# Product/Process Change Notice (PCN)

File Number #: ConUSB\_20150703\_61400416021

Product Affected: 61400416021

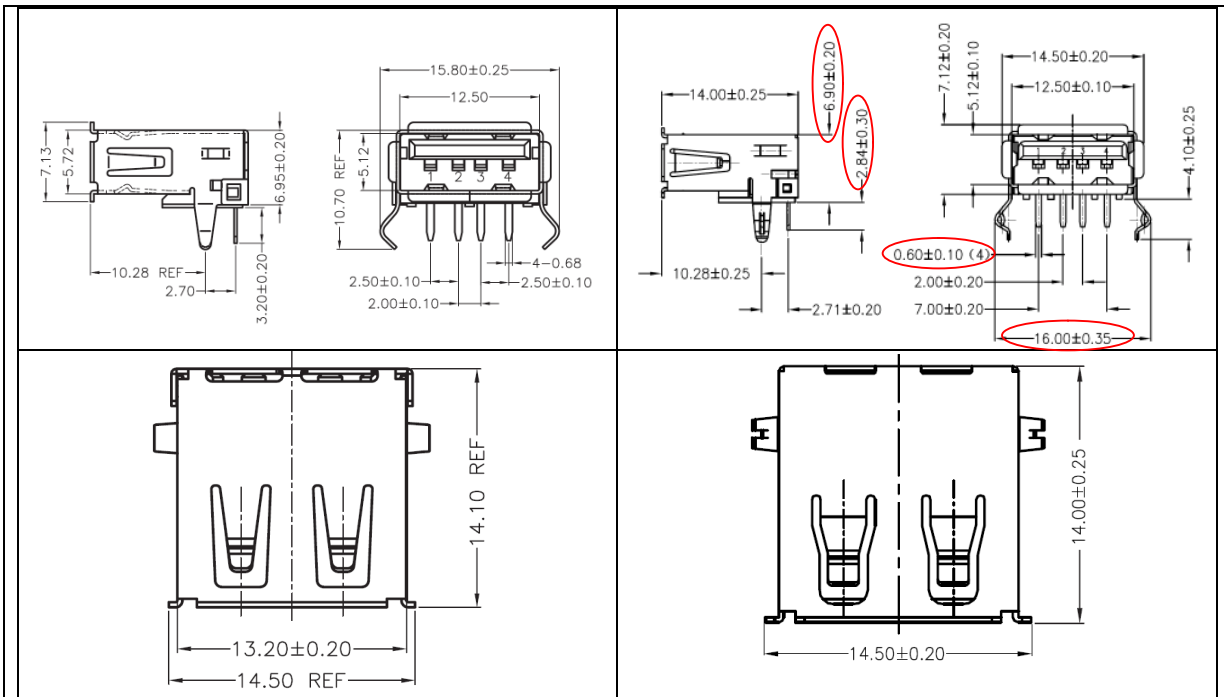
A fully automatized process will be implemented and CCD inspection controls will be added. The design changes are summarized below and marked in red:
